Design Review Report – Item 1

Local government:	City of Stirling	
Item no.:	Item 1 - DA24/0211 – 942 Beaufort Street, Inglewood – Development Application - Residential – Four Multiple Dwellings	
Acting Chairperson:	Philip Gresley	
Panel members:	Brett Wood-Gush Stephen Carrick Peter Ciemitis	
Local government officers:	Karina Bowater Casey Hill Simone Palmer	Acting Coordinator Planning Senior Strategic Planning Officer – City Future DRP Support Officer
Observers	Andrew Lefort Ronni Howe Mason Grosse Meron Nega	Manager City Future Senior Planning Officer Heritage Strategic Planning Officer – City Future Planning Officer
Date:	4 July 2024	Time: 2pm
Venue:	City of Stirling – Challenger Room

SOUTH-EAST ELEVATION - FACING LOT 401

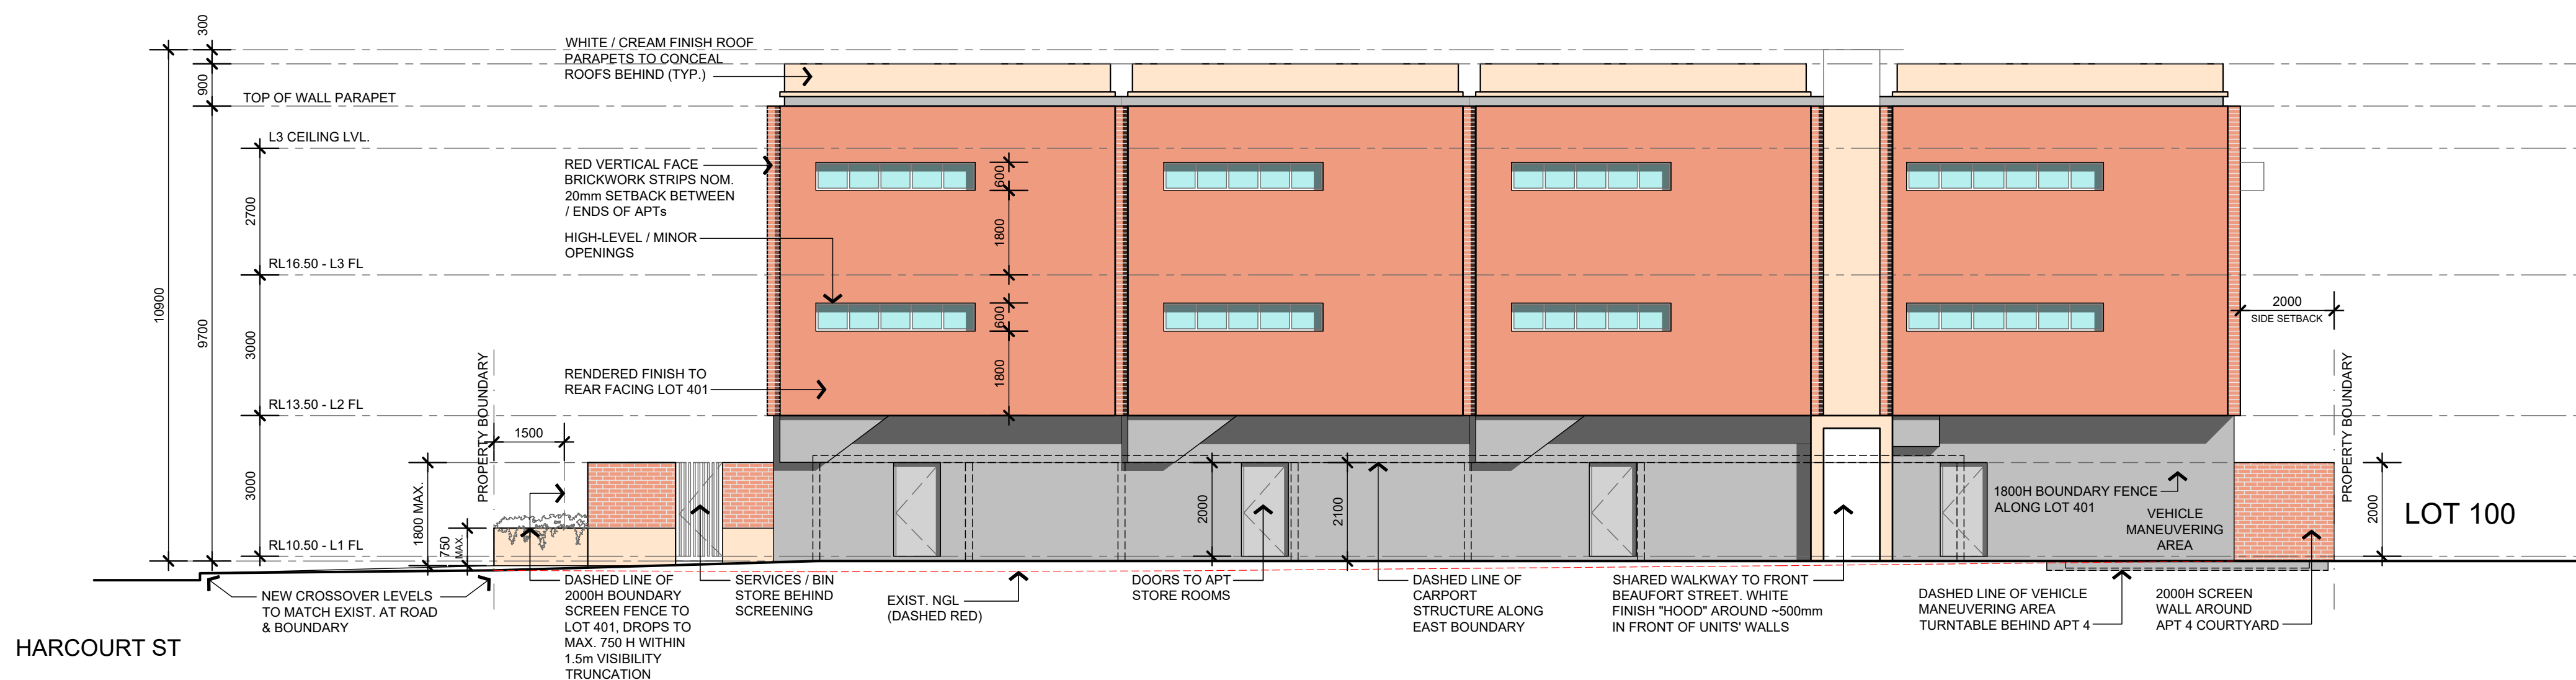
narrow vertical windows could incorporate shading devices to assist with heat load. 1h. The Panel stated the rear south-east façade is blank and will benefit from additional attention. There is opportunity to wrap elements or language developed on the other facades around the corners to better unify the quality of the development when viewed in the round. 1i. The Panel supports the more transparent fencing option and has concerns about the two-metre-high brickwork option. The Panel understands the acoustic requirements and suggests, if possible, these be resolved by alternate means. There is opportunity to balance CPTED (passive surveillance), privacy, and acoustics requirements though including a variety of solid and transparent sections to the fencing. This interface with the public realm is critical to get right. 1j. The immediate context could be better explained through a large section drawing running from the neighbouring house through to the opposite side of Beaufort St, which would show the character of the street and the proposal's impact on the public realm. 1k. The simple and more contemporary detailing was encouraged by the Panel.

LANDSCAPING PLAN

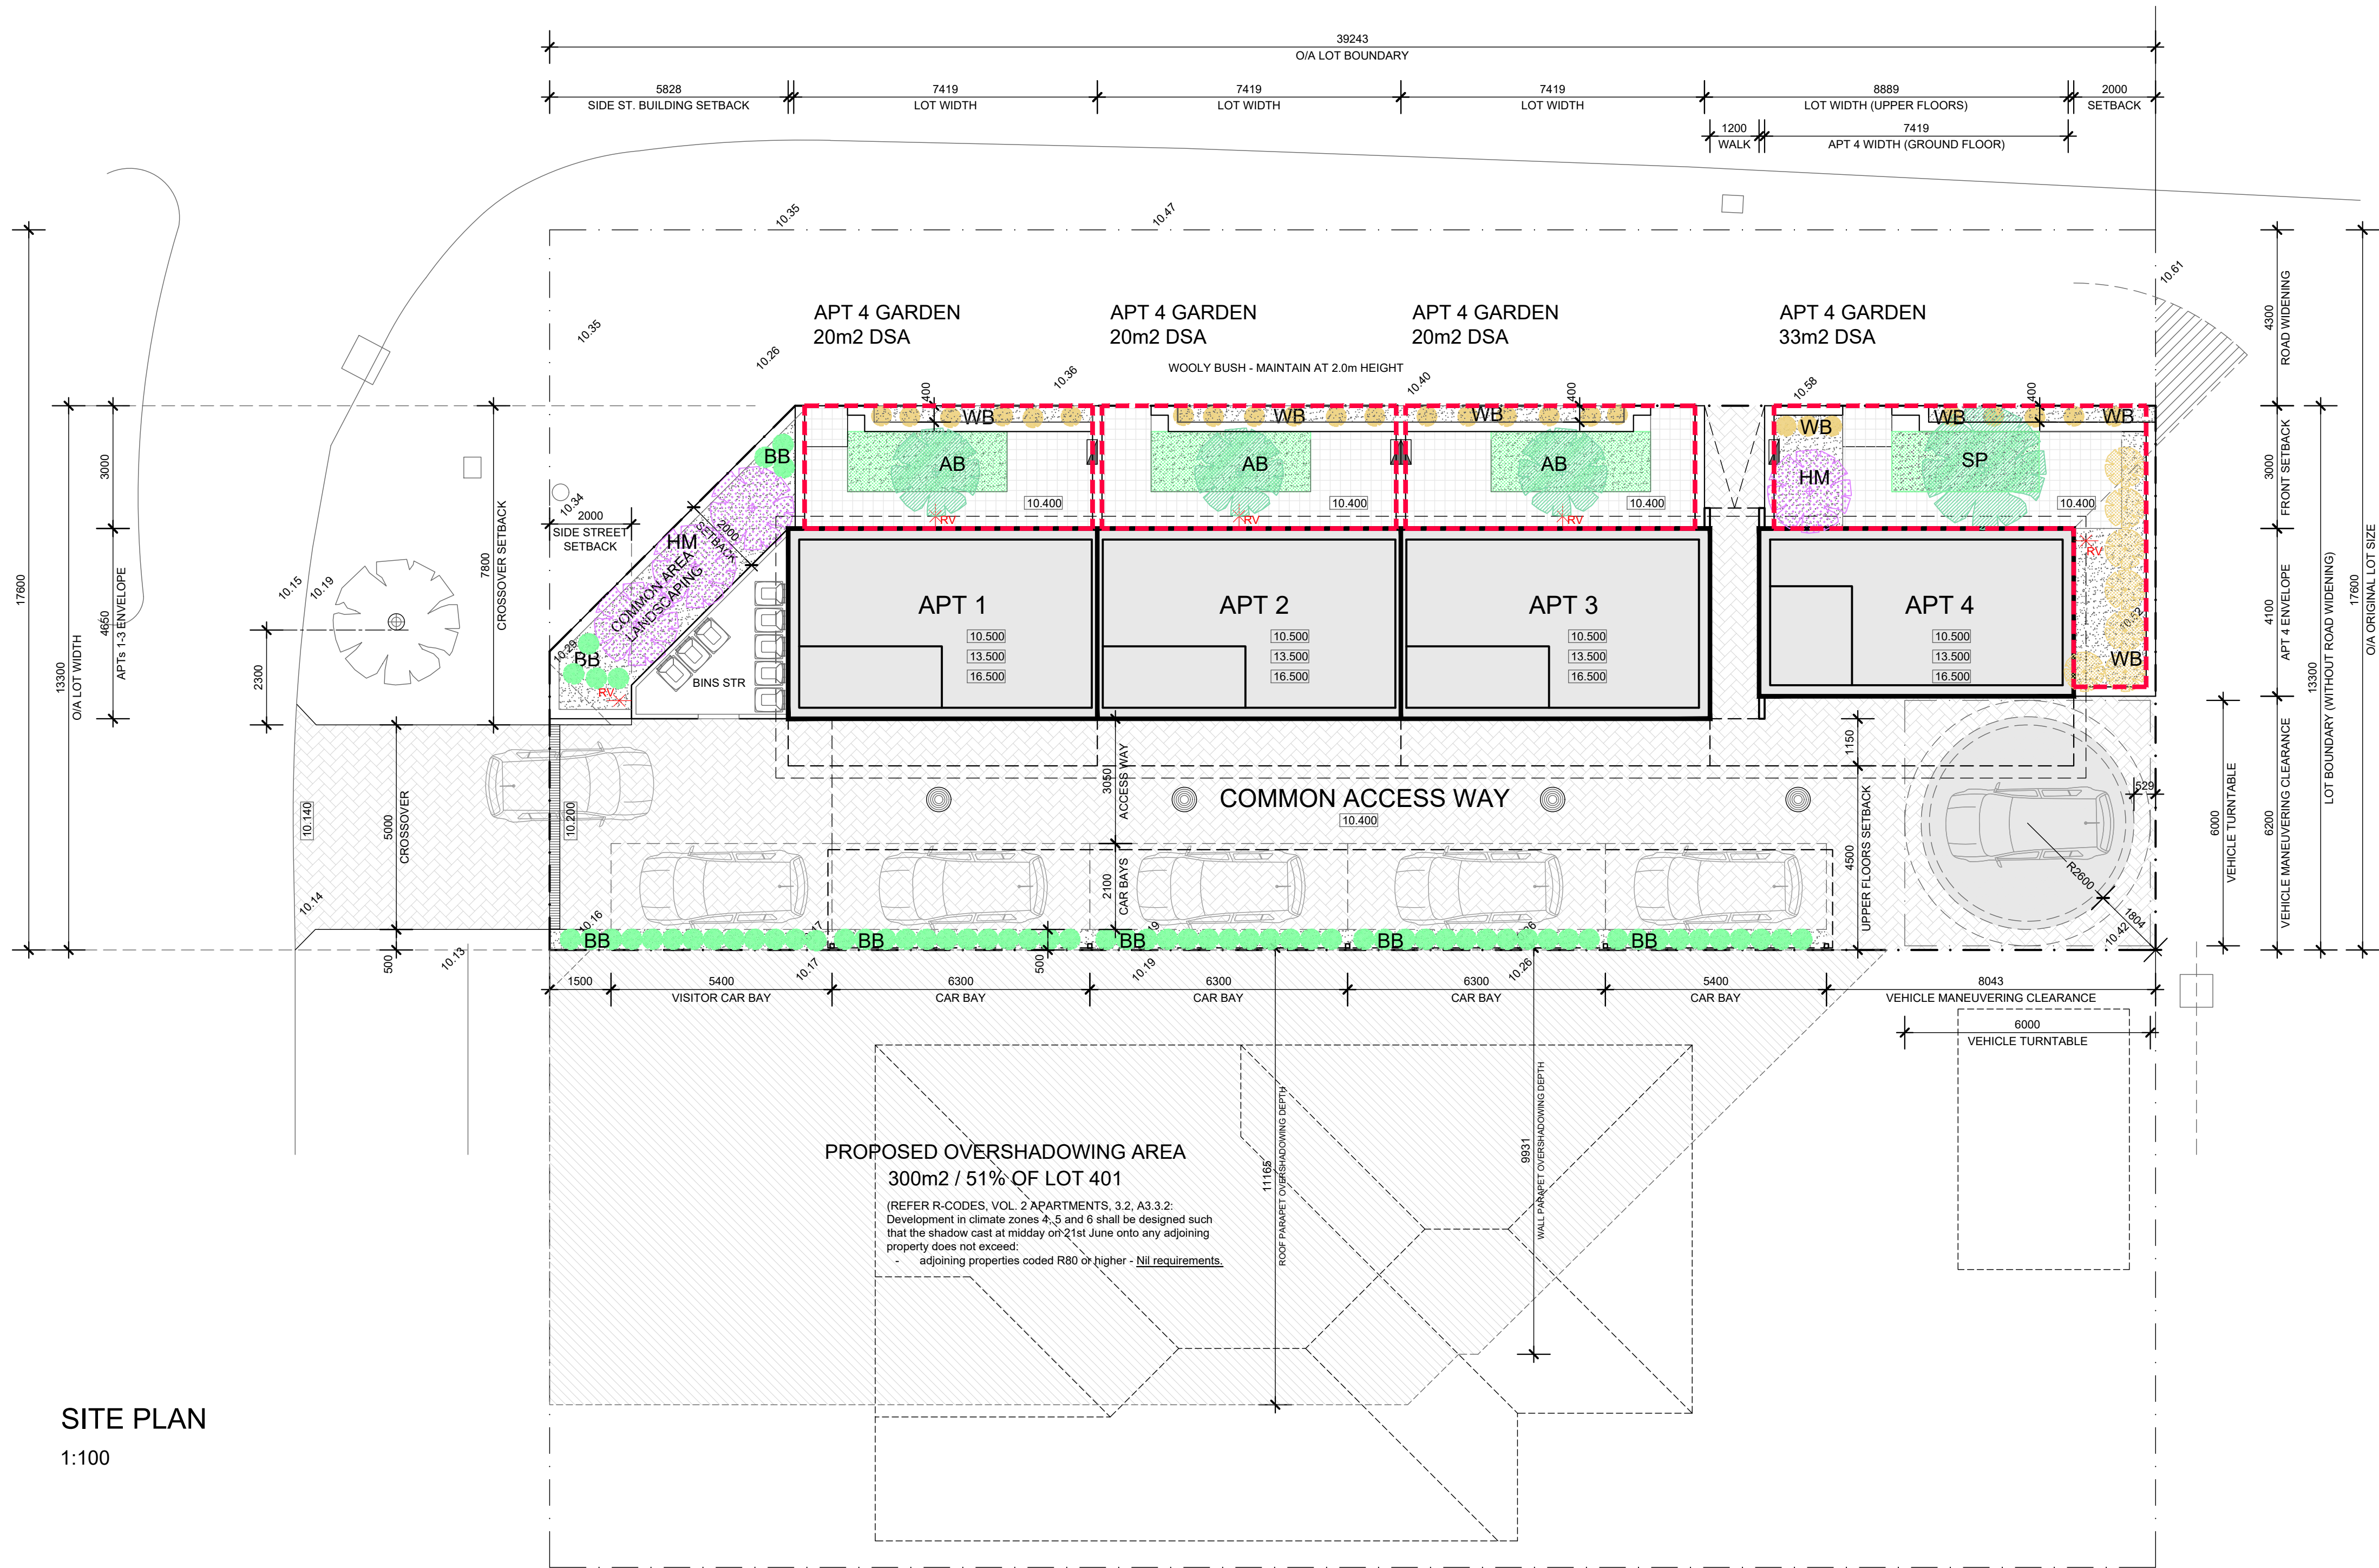
2a. The Applicant was encouraged to work harder to meet and exceed deep soil calculations which there

is a significant shortfall. 2b. The Panel suggests that making a contribution to the public realm landscaping within the road widening setback could provide additional street trees, increase CPTED, improve legibility and amenity to residents with individualised entry pathways and ultimately improve what could otherwise be a large and hot expanse of empty paving. In this instance, acknowledging the complexity and constraint on the site may support the provision of landscaping in the public realm in lieu of on-site. The Applicant was urged to engage with the City on how this can be achieved. 2c. It was suggested additional trees could be included on the ground floor on the northern end of the development. 2d. It was suggested the trellis to the carpark could be softened and that this was a good landscape device to be further considered. 2e. It was suggested landscaping on the boundary to the east could be increased if the vehicle turnaround was shifted.
